AS-BUILT/
CONSTRUCTED

DESIGNED BY: HMR		PROJECT TITLE FOREST LAKES BRIDGES		PROJECT LOCATION MONUMENT, CO	
DRAWN BY: AJM		SUMMARY OF QUANTITIES			
PROJECT MANAGER HMR					
DATE 7/12/22					
		STRUCTURE JOB:		SHEET NO. B02

FOREST LAKES BRIDGES

FOUNDATION LAYOUT

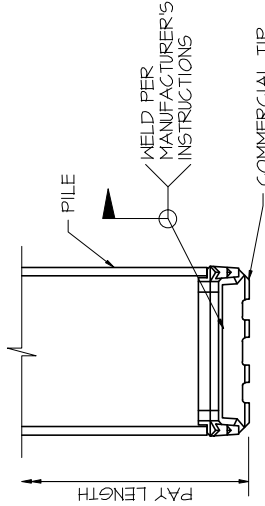
Per the pile driller, piles were embedded +/- 3' into bedrock. Piles were driven until the N count = 120 blows.

ELEVATION

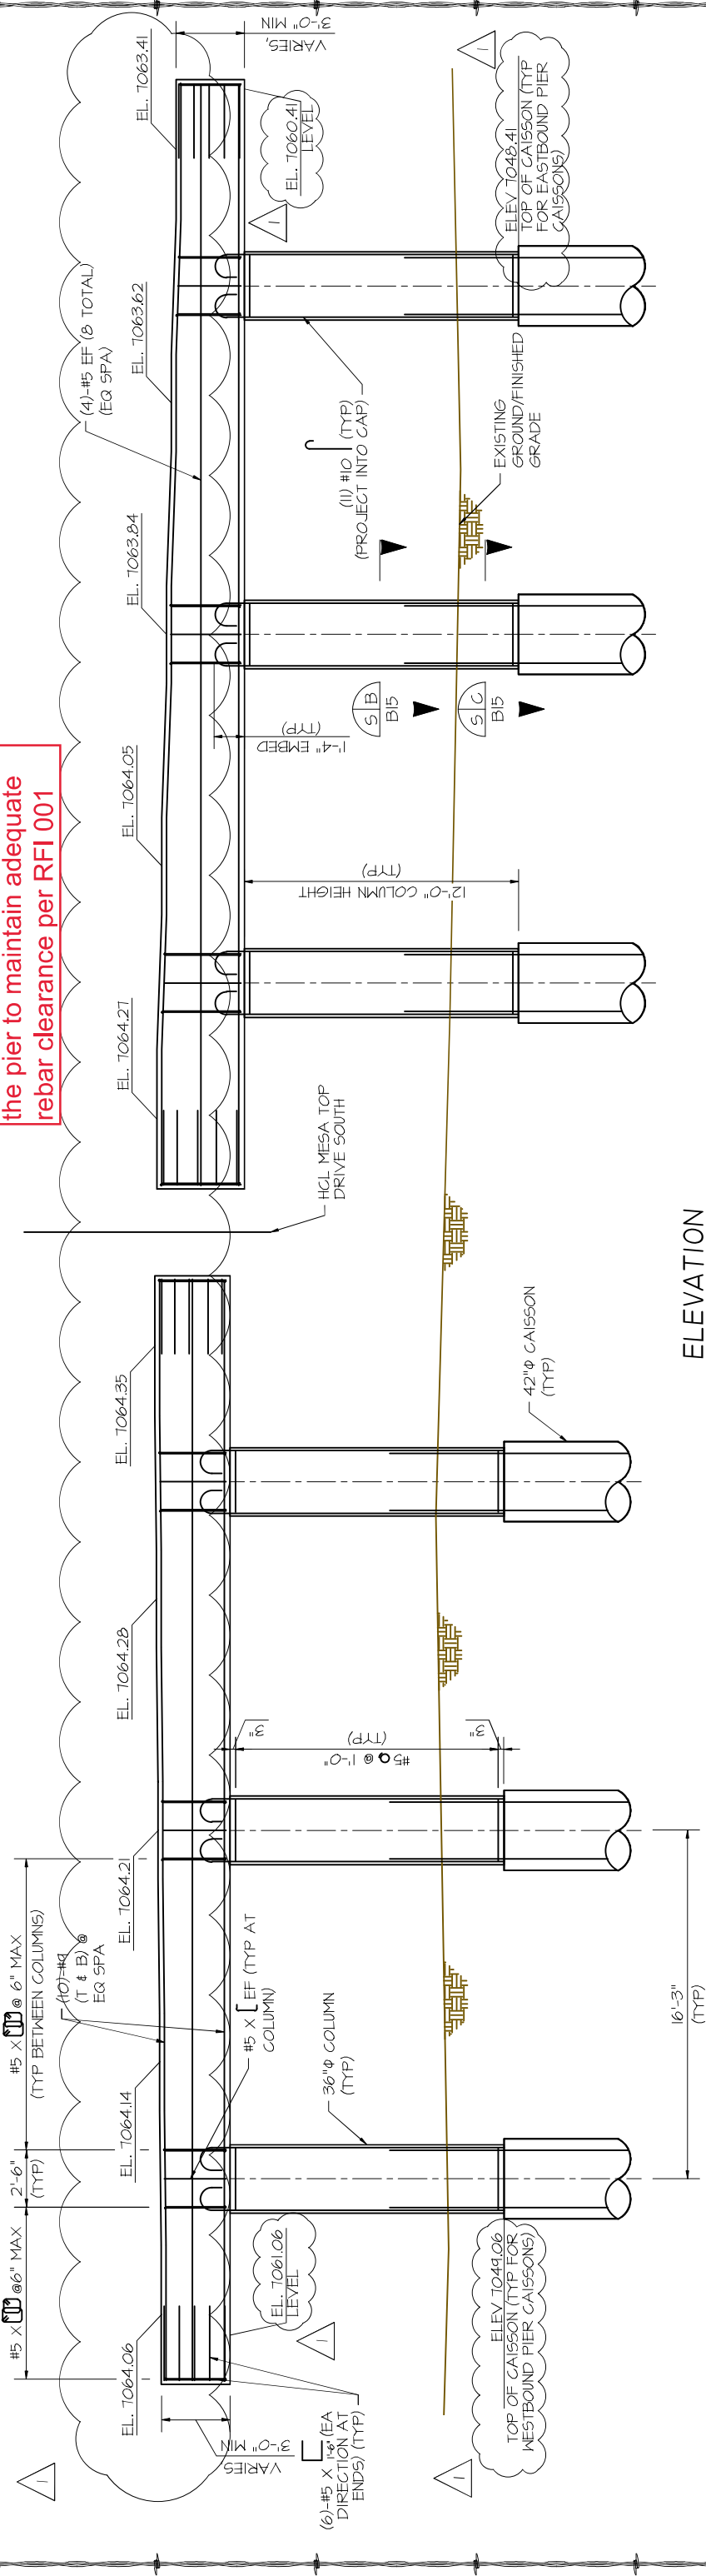
This column was shifted 2" to the southeast along the CL of the pier to maintain adequate rebar clearance per RFI 001
